CITY OF SAN ANTONIO

Re: The Meadows Subdivision

MDP # 693-A

The City Staff Development Review Committee has reviewed The Meadows Master Development Plan M.D.P. # 693-A. Please find enclosed a signed copy for your files. Your plan was accepted, however please note the following:

MEALLION HOMES
 THE MEADOWS SUBDIVISION
 P.O.A.D.P.

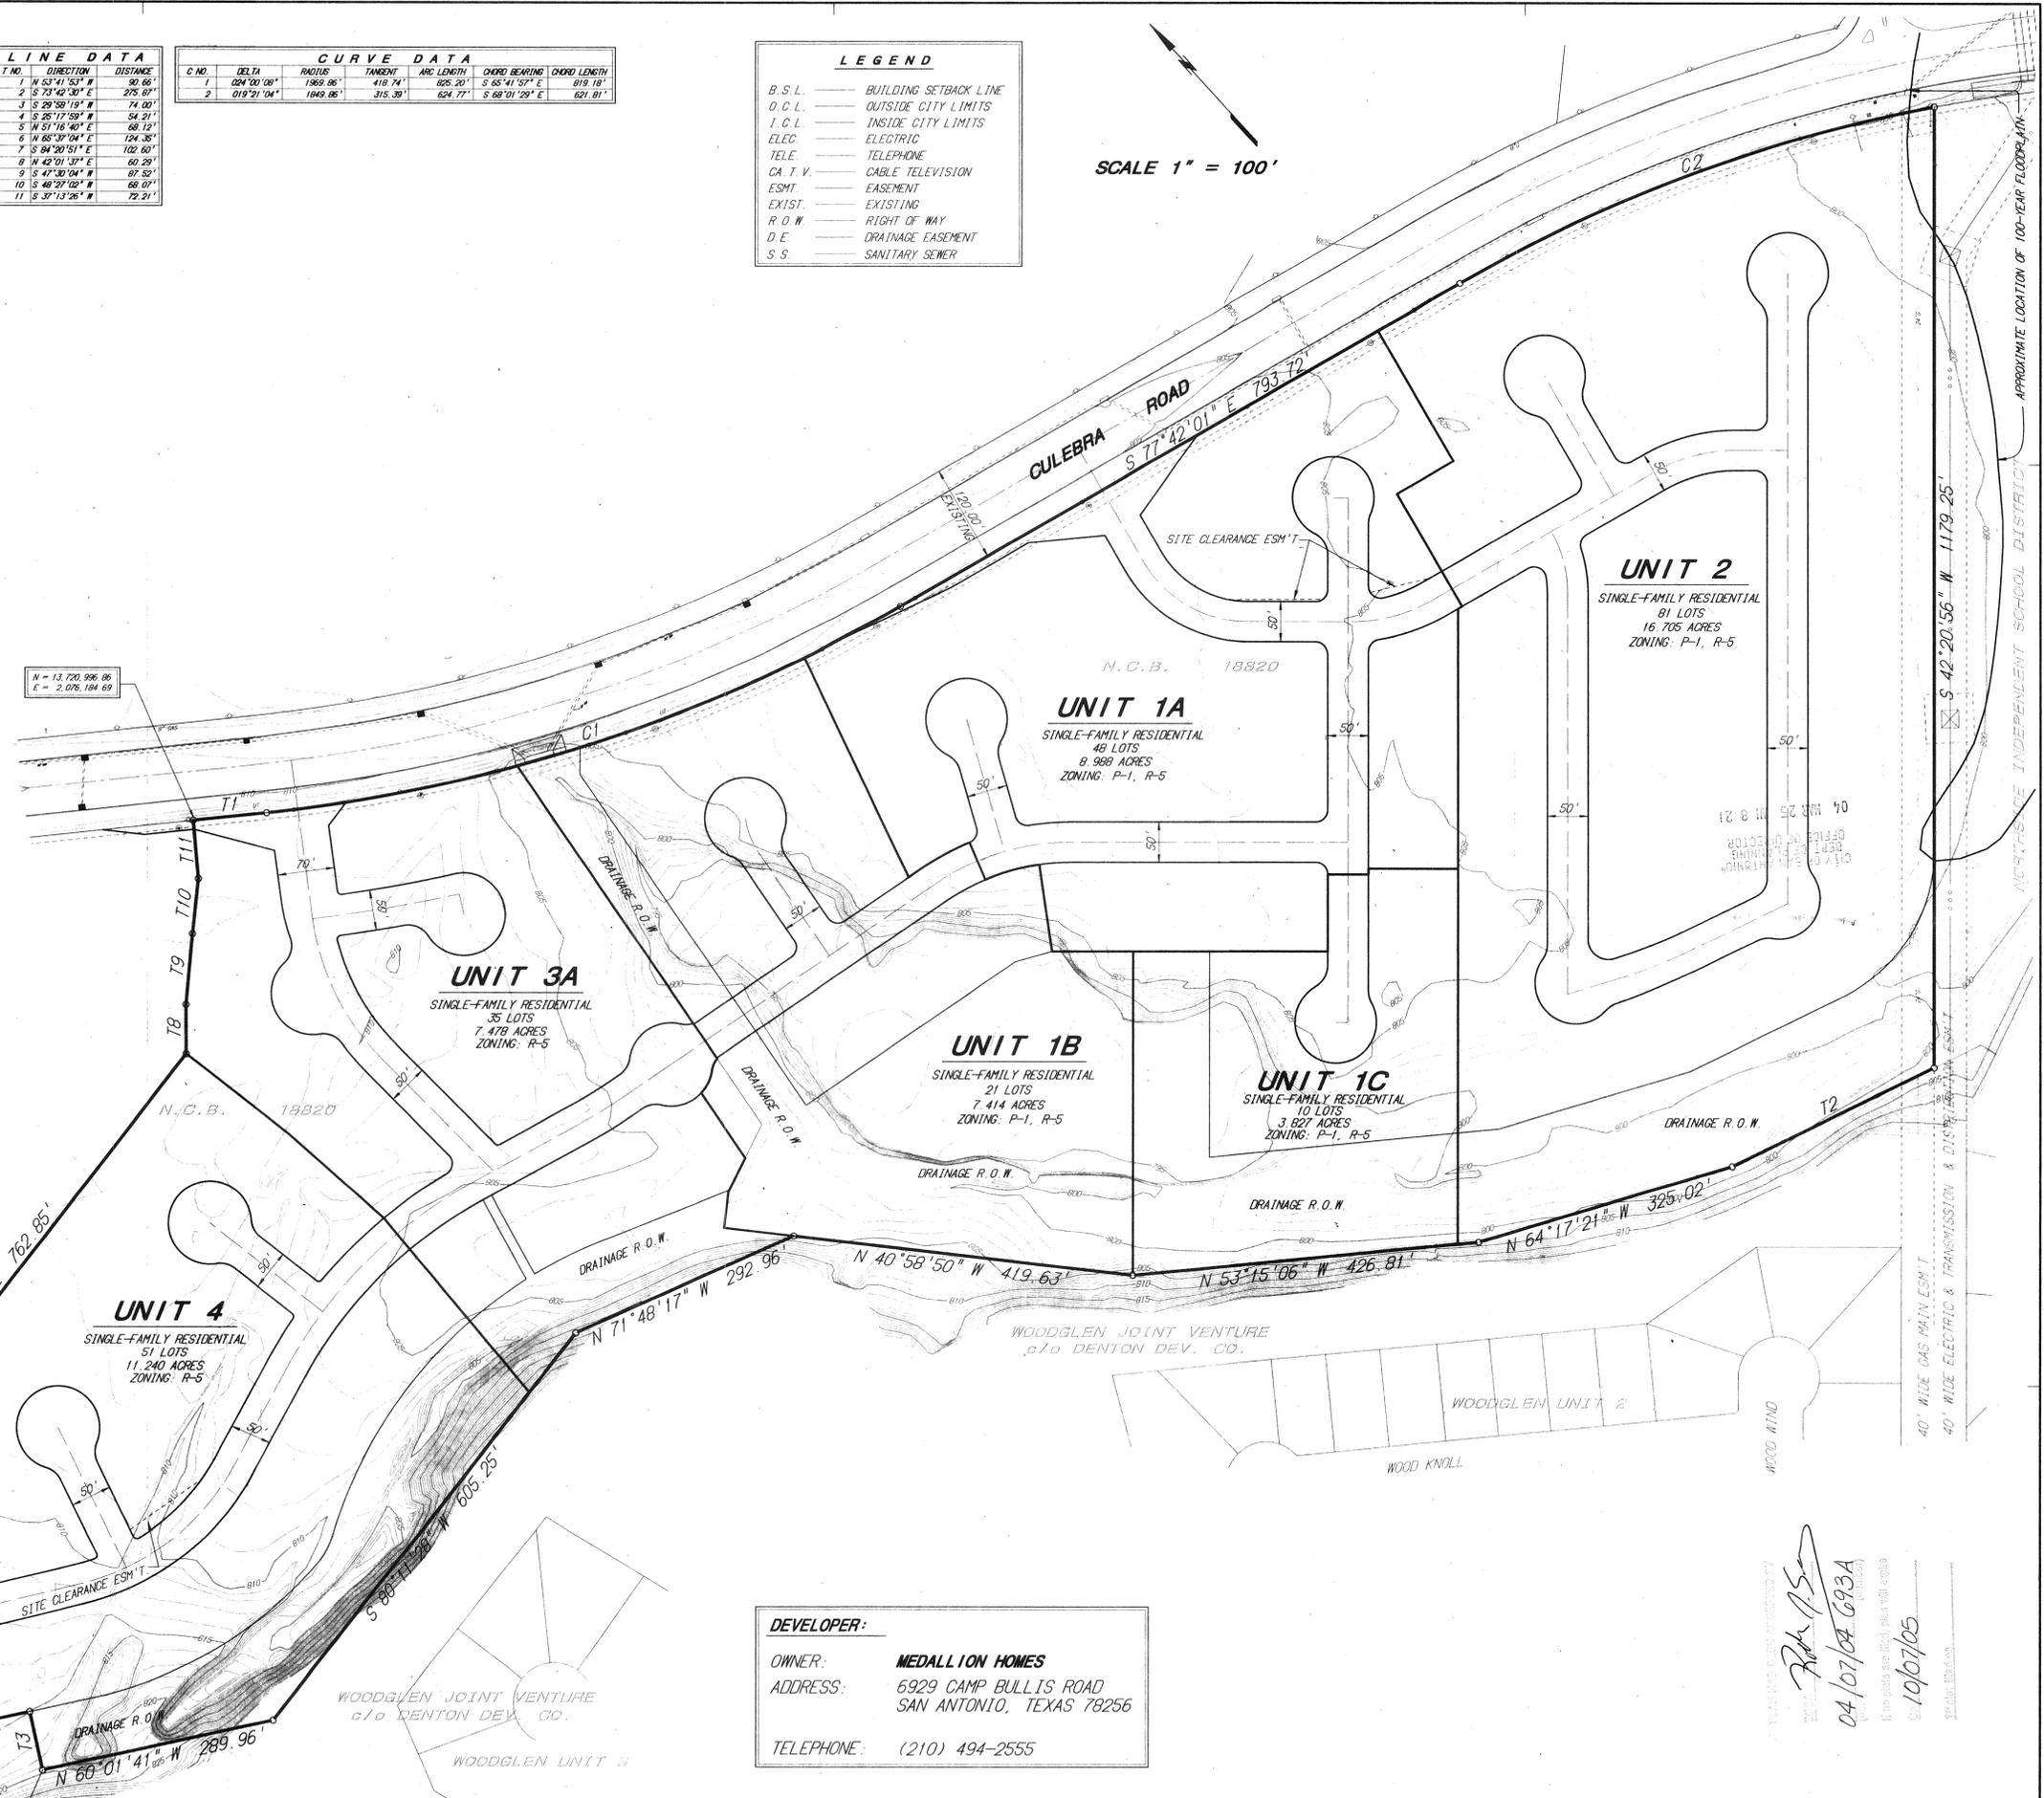
- In consideration of public safety and convenience, excessive grades by reason of topography should be avoided in street layouts and arrangements.
- Development Services, Engineering Section has indicated as part of their conditional approval:

1. Drainage feature shall be built for Unit-1B.
 2. Right Turn deceleration lane shall be coordinated with TxDOT.
- Any access and R.O.W. issues along state facilities will need to be resolved with the Texas Department of Transportation (TXDOT). For information about these requirements you can contact TXDOT at 615-5814.

- This development will need to comply with tree preservation ordinance #85262. For information about these requirements you can contact Tree Preservation at 207-8053.

- I would encourage you to work closely with the school district, so that they can plan accordingly.
- It will be expected that you will plat all of the property depicted in your Master Development Plan (M.D.P.) to include floodplains, drainage areas and open space.

Under the conditions as stated in the Storm Water Management Report, this development under today's regulations would be allowed to pay the Storm Water Fee.

1. This project is eligible for regional storm Water Management Participation (FILO).
